EPRI Groundwater Assessment for TVA's Sequoyah Nuclear Plant

Assessment Final Report

Onsite Evaluation Dates: March 26, 2007 through March 30, 2007

Figure 2

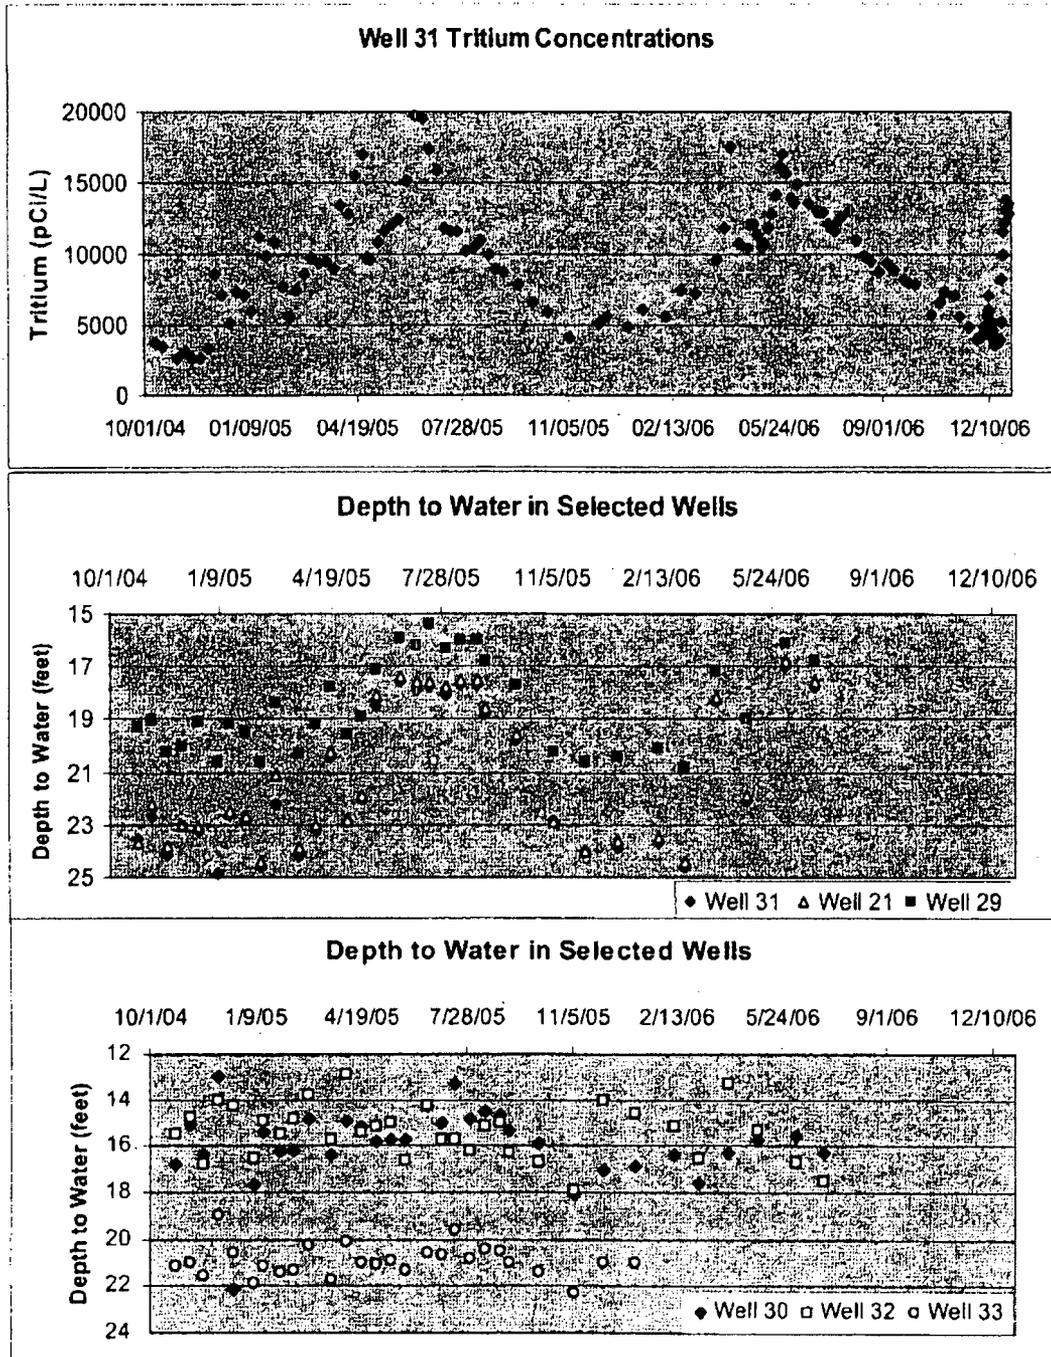
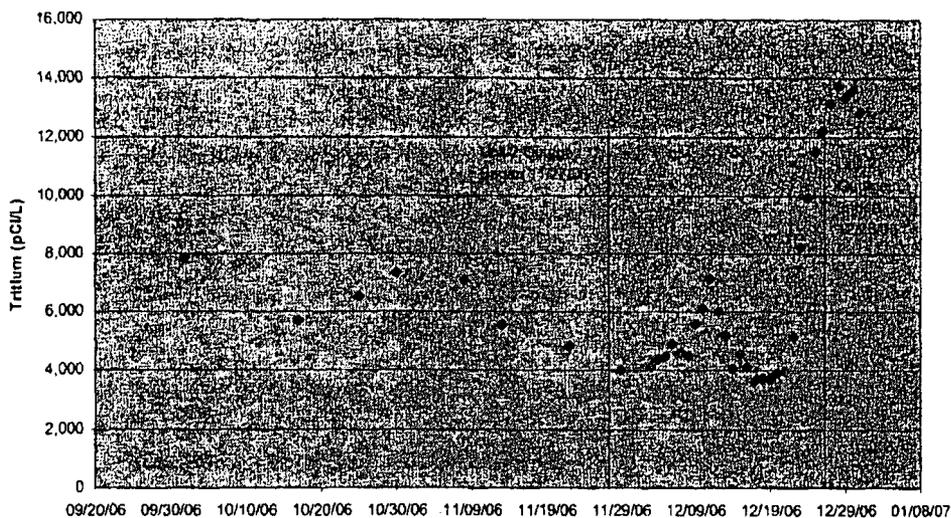
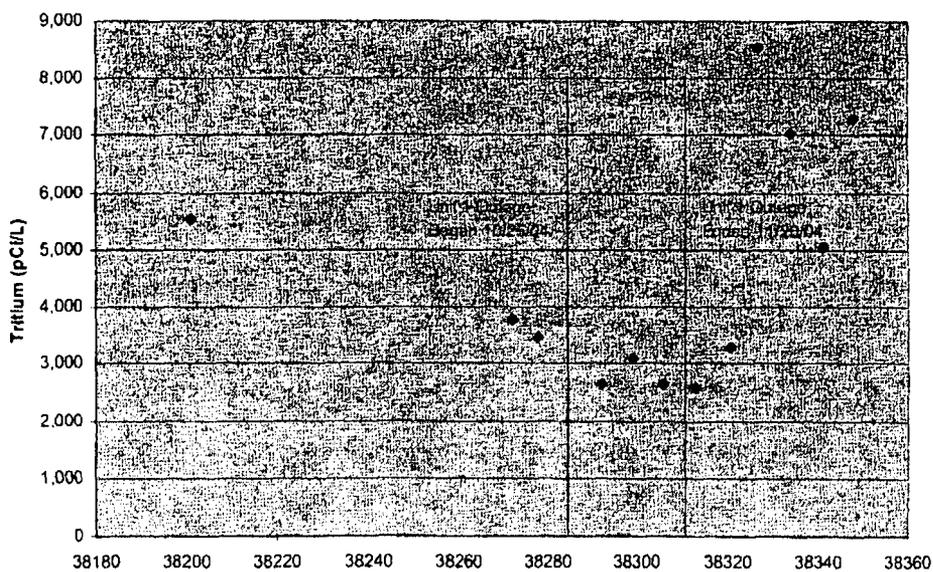
Figures 2 and 3 show the variation in tritium levels in Well 31 during the periods spanning the last two refueling outages in Unit 2 and Unit 1, respectively. These figures show that tritium concentrations in Well 31 are lowest during the outages and increase immediately following the outages. Because the flow of cooling water is reduced during outages, it is likely that the water level in the discharge channel is lower during outages. Lower tritium levels in Well 31 during outages support the conceptual model of rising groundwater remobilizing tritium from historical surface spills that is suspended in the vadose zone.
